ADDENDUM No. 8
TO THE
CITY OF FRESNO
PUBLIC WORKS STANDARD DRAWINGS AND SPECIFICATIONS
ADOPTED MARCH 4, 1970, BY RESOLUTION NO. 70-36

THIS UPDATED VERSION IS APPROVED: JANUARY 30, 2023

Addendum 8 to the Public Works Standard Drawings and Specifications, dated January 30, 2023

BUS LAYOVER PAD CONSTRUCTION DETAIL & NOTES

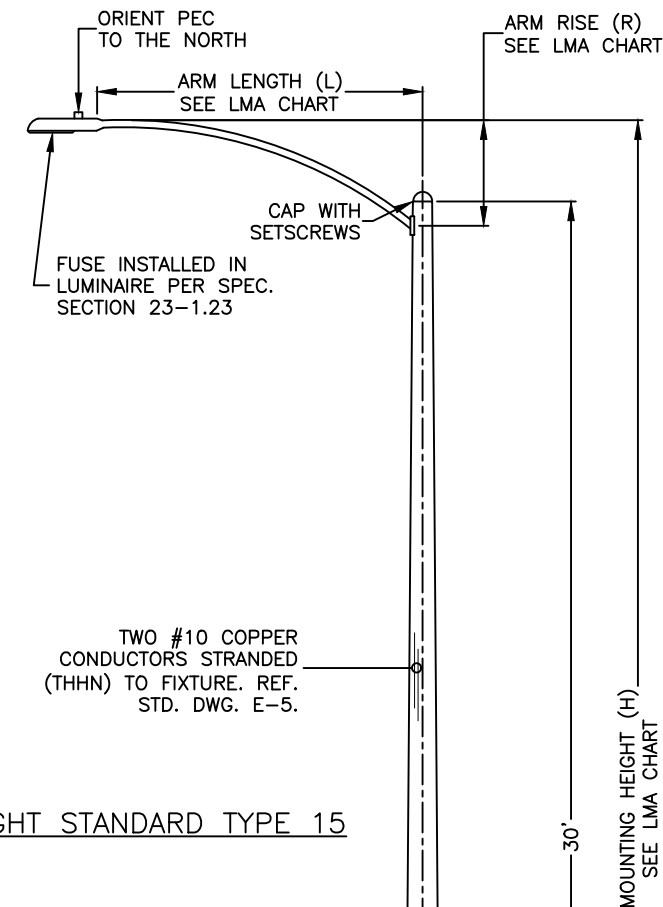
FAX-3	1. New Standard Drawing: “BUS LAYOVER PAD CONSTRUCTION DETAIL & NOTES”
FAX-4	<ol style="list-style-type: none"> 1. NEW Standard Drawing: “BUS BAY DETAILS”. 2. Includes detail, “REINFORCED CURB AND GUTTER” previously shown on Std. Dwg. P-73. 3. Callouts included on previous detail were converted to Notes 3-5. No technical changes were made to detail.

1. CONCRETE PAD SHALL BE 10" PCCP WITH #5 GRADE 60 REBAR AT 16" O.C., EACH WAY, TOP AND BOTTOM. USE 3" REBAR SPACERS WITH WIRE TIES (DOBIES). CONCRETE SHALL BE CLASS "A", 6-SACK. ALL FINISH SHALL BE MEDIUM BROOM.
2. PLACE 6" CLASS II AB (95% R.C.) OVER 6" CNS AT 95% R.C.
3. AC PATCH SHALL BE 6.5" AC (TYPE A) OVER 8.5" CLASS II AB ON 6" CNS AT 95% R.C.
OPTIONAL: 12" AC (TYPE A) ON 6" CNS AT 95% R.C. MAY BE USED AS AN ALTERNATIVE
4. PROVIDE GRADE BREAKS PER PLAN. IF SIGNIFICANT FIELD ADJUSTMENTS ARE NECESSARY DUE TO UNFORESEEN CONDITIONS CONTACT CONSTRUCTION MANAGEMENT IMMEDIATELY FOR GUIDANCE AND APPROVAL BY THE PROJECT ENGINEER

STREETLIGHT-WITH BASE
INCLUDES PULL BOX & PVC CONDUIT

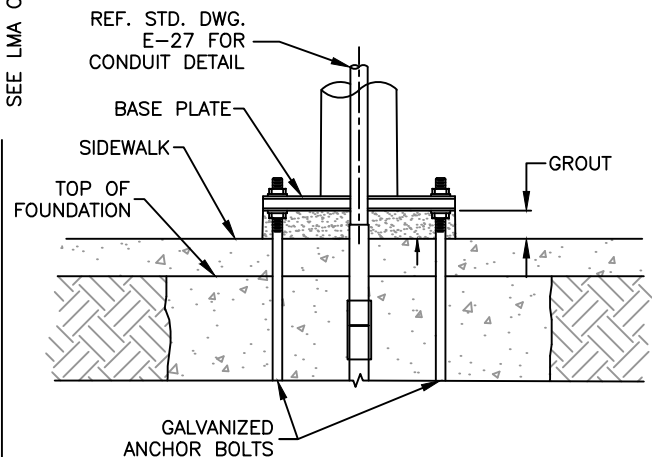
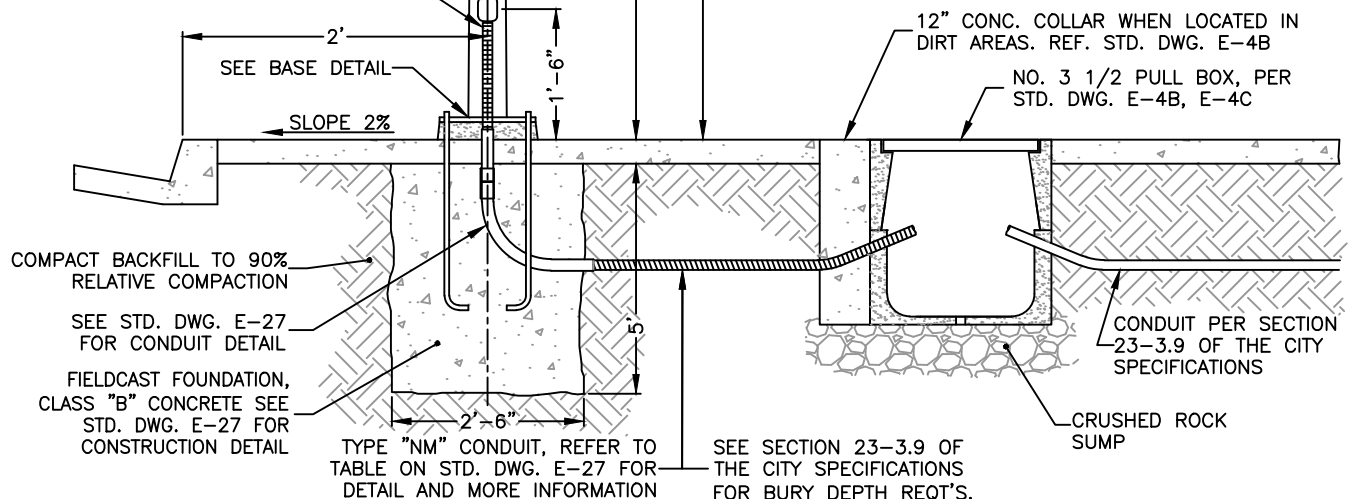
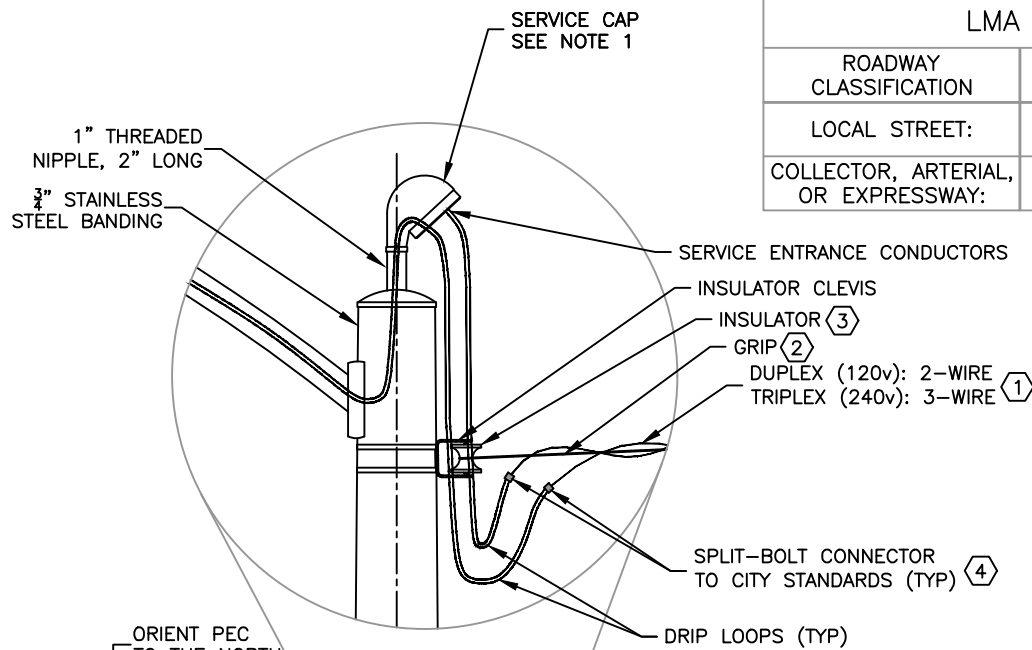
DPW – ELECTRICAL	
E-1	<ol style="list-style-type: none"> 1. Minor changes to BASE DETAIL, including clearer depiction of sidewalk concrete section and removal of linework and callouts referring to “FORMED” concrete. 2. Added callout to BASE DETAIL: “SIDEWALK”. 3. Added leader to “TOP OF FOUNDATION” callout.
E-1A	1. New Standard Drawing , “STREETLIGHT – OVERHEAD FEED”.
E-5	<ol style="list-style-type: none"> 1. Drawing modified to depict/require all leads to be pulled/looped in the pole handhole. 2. Added note 2: “ALL CONDUCTORS SHALL BE PULLED INTO HANDHOLLE WITH 18” MIN. SLACK PROVIDED”.
E-27	<ol style="list-style-type: none"> 1. Standard Drawing title: “SIGNAL LIGHT FOUNDATION WIRE-WAY DETAIL” revised to read: “SIGNAL & STREET LIGHT FOUNDATION AND WIRE-WAY DETAIL” 2. Drawing modified to depict sidewalk, show entire foundation including anchor bolts and light pole base plate mounting. 3. Added detail: “ANCHOR CONNECTION DETAIL” and table for min./max. offset between top of sidewalk and bottom of base plate.

STREETLIGHT-OVERHEAD FEED
USE ONLY AS APPROVED BY THE CITY ENGINEER

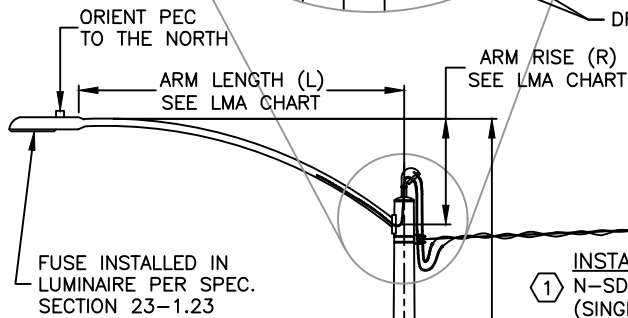
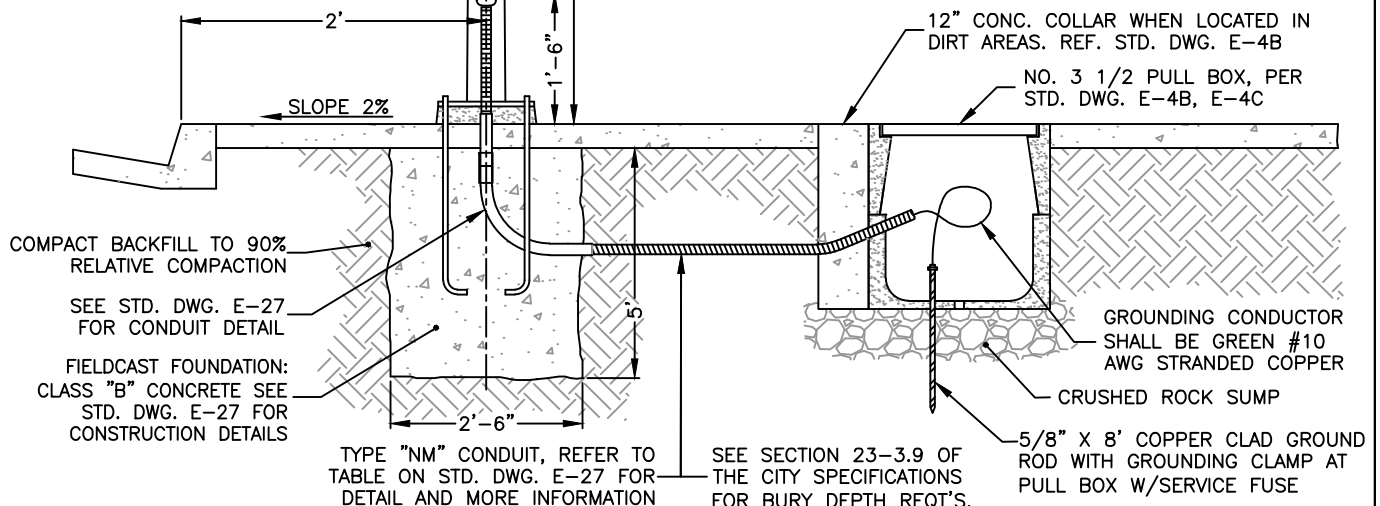
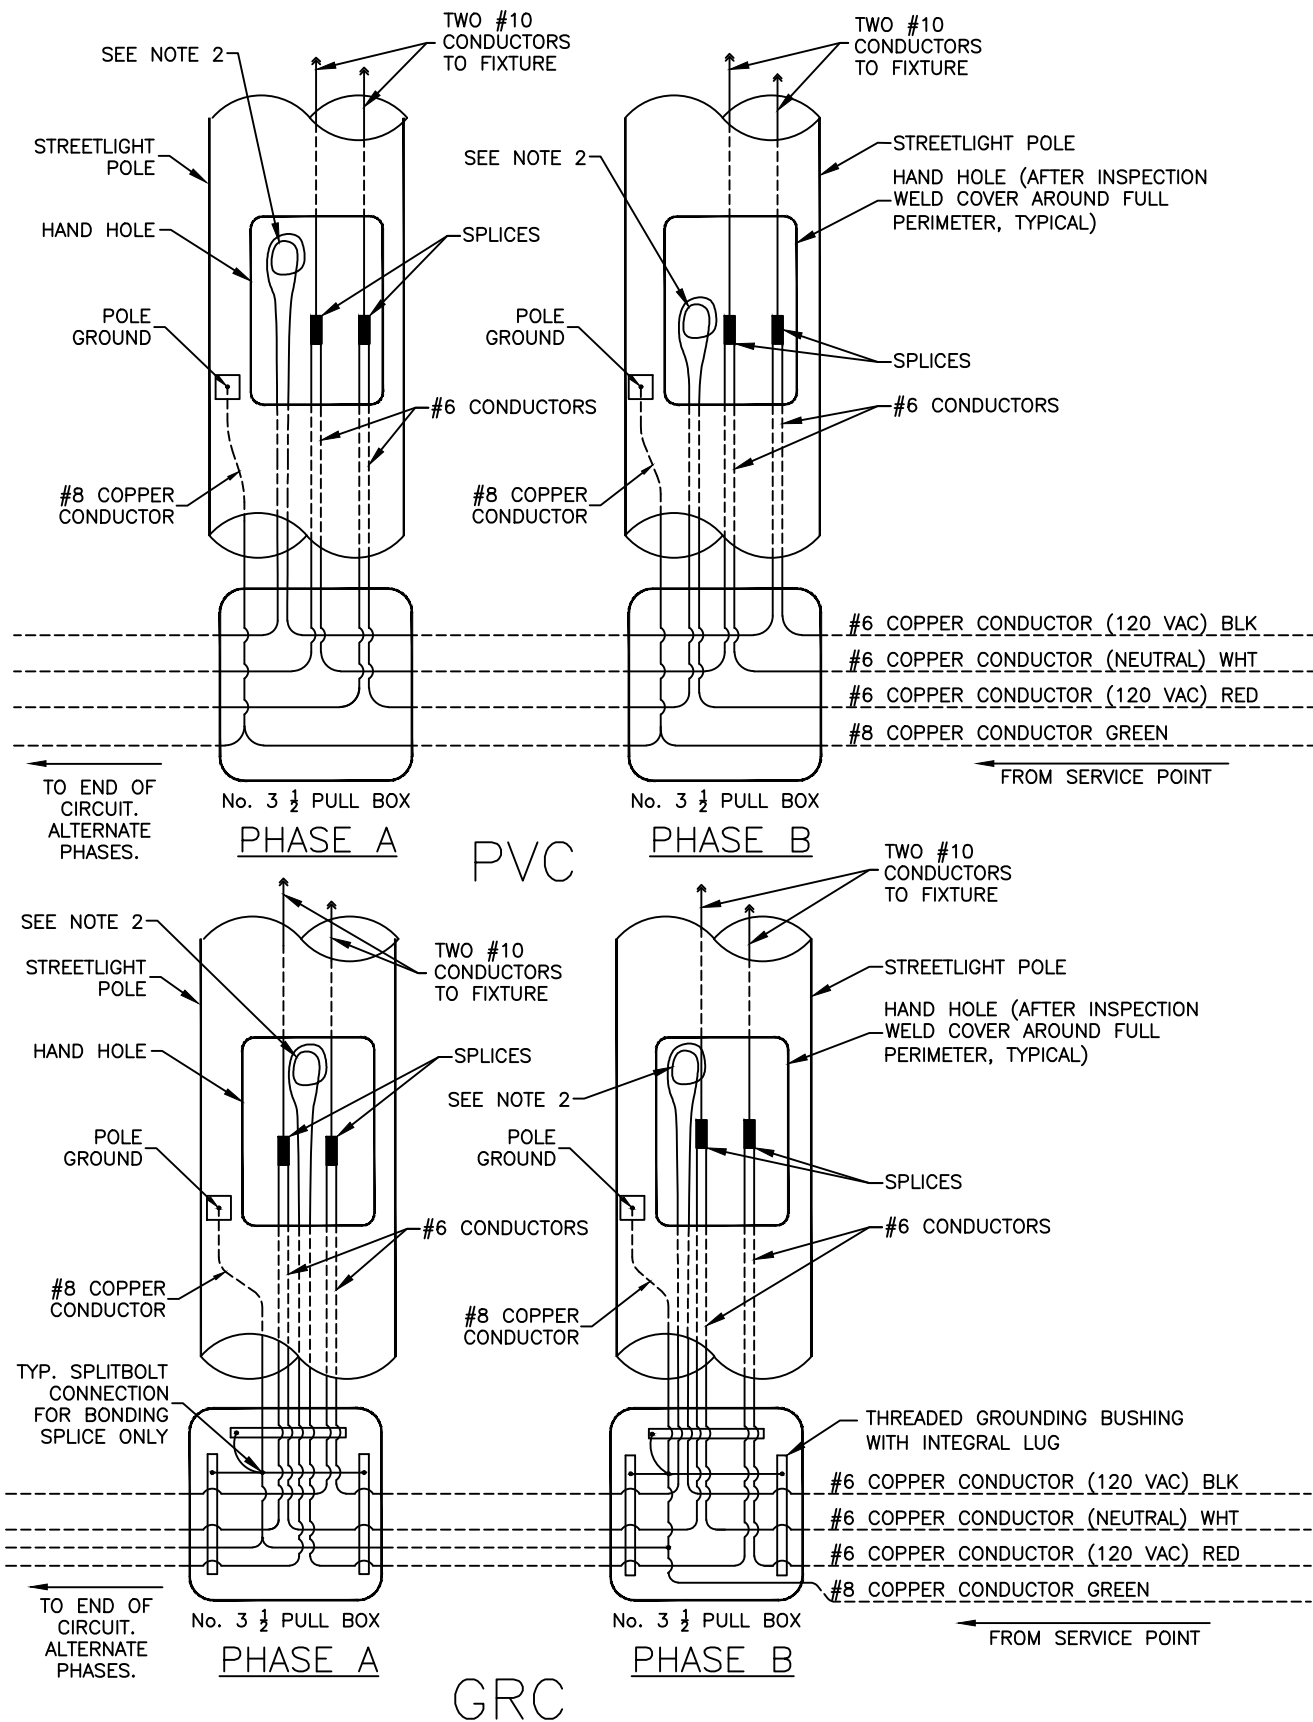
4. Added various callouts to base detail regarding materials and construction requirements.
--	--

FIRE HYDRANT INSTALLATION

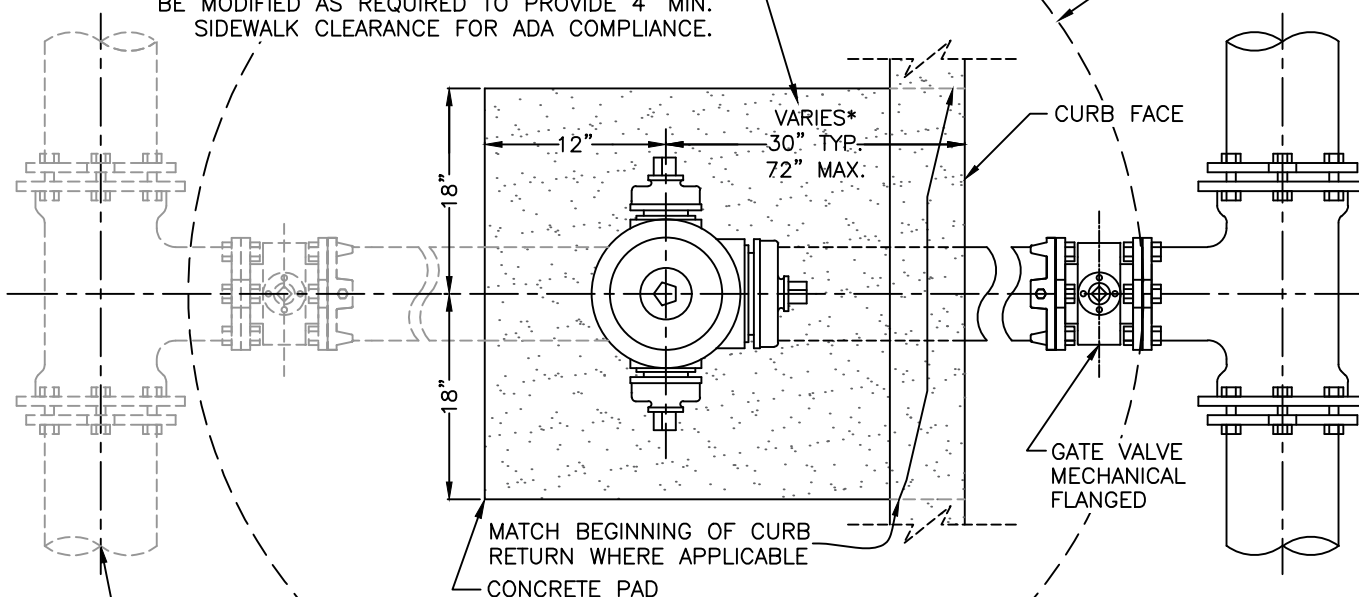
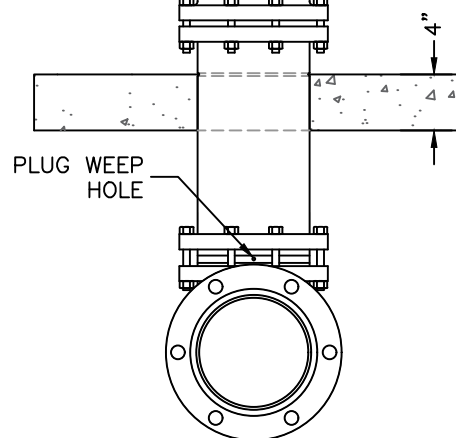
DPU – WATER	
W-3	1. Added Note 4 , “FIRE HYDRANTS SHALL BE PLACED AT INTERVALS OF 600' FOR RESIDENTIAL DEVELOPMENTS AND 450' FOR COMMERCIAL DEVELOPMENTS. LOCATION APPROVAL REQUIRED BY CITY FIRE DEPARTMENT.”

1. GATE VALVE TO BE TIED TO MAIN PER STD DWG W-37
2. CAP AND OPERATING NUTS ARE 1-1/8" PENTAGON
3. WHERE MAIN LIES BEHIND CURB, PIPE & VALVE DETAILS SHALL BE REVERSED
4. FIRE HYDRANTS SHALL BE PLACED AT INTERVALS OF 600' FOR RESIDENTIAL DEVELOPMENTS AND 450' FOR COMMERCIAL DEVELOPMENTS. LOCATION APPROVAL REQUIRED BY CITY FIRE DEPARTMENT.
